Work Order ID 139375

Item ID: D212-725-1-217F Accept ***N900040100*** Setup Start ***NS1***
 Revision ID: Stop ***NS2***
 Item Name: Web
 Start Date: 11/26/2015 Start Qty: 2.00 ***2*** Cust Item ID:
 Required Date: 1/11/2016 Req'd Qty: 2.00 ***2*** Customer:
 Reference:

D212-725-1-217F FLAT PATTERN

DESIGN	RF	DART AEROSPACE LTD HAWKESBURY, ONTARIO, CANADA	
DRAWN	RF		
CHECKED	<i>[Signature]</i>	DRAWING NO.	REV. B
MFG. APPR.	<i>[Signature]</i>	D4258	SHEET 5 OF 13
APPROVED	<i>[Signature]</i>	TITLE	SCALE
DE APPR.	<i>[Signature]</i>	SHIELD TAIL PIPE ASSEMBLY	NTS
DATE	12.11.15	COPYRIGHT © 2011 BY DART AEROSPACE LTD THIS DOCUMENT IS PRIVATE AND CONFIDENTIAL AND IS SUPPLIED ON THE EXPRESS CONDITION THAT IT IS NOT TO BE USED FOR ANY PURPOSE OR COMMUNICATED TO ANY OTHER PERSON WITHOUT WRITTEN PERMISSION FROM DART AEROSPACE LTD.

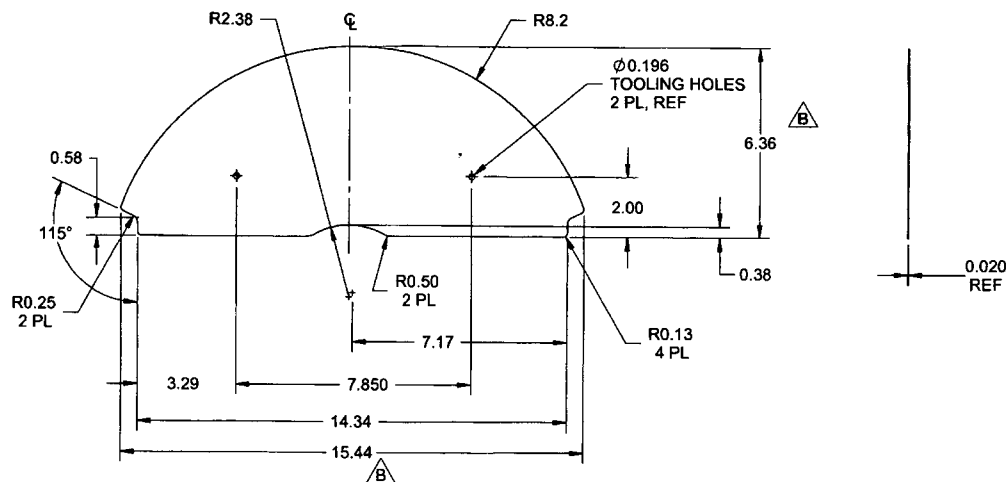
Description Work Order Deviation	Disposition	15.12.01
0.025 THK (24 GAUGE) USED	ACCEPTABLE, OPEN PAR TO CHANGE ON D212-7 D4258 DRAWING, MTL SHOULD READ "0.025 THK (24 GAUGE)"	Completed By <u>A.P.</u> 15.12.01
		Lead hand / Supervisor Approval Verification DAS 9 9-89 15.12.15
	PAR 16-482 UNACCEPTABLE METHOD FOR MATERIAL DEVIATION	QC / QA Coordinator Approval DAS 9 9-89 15.12.15
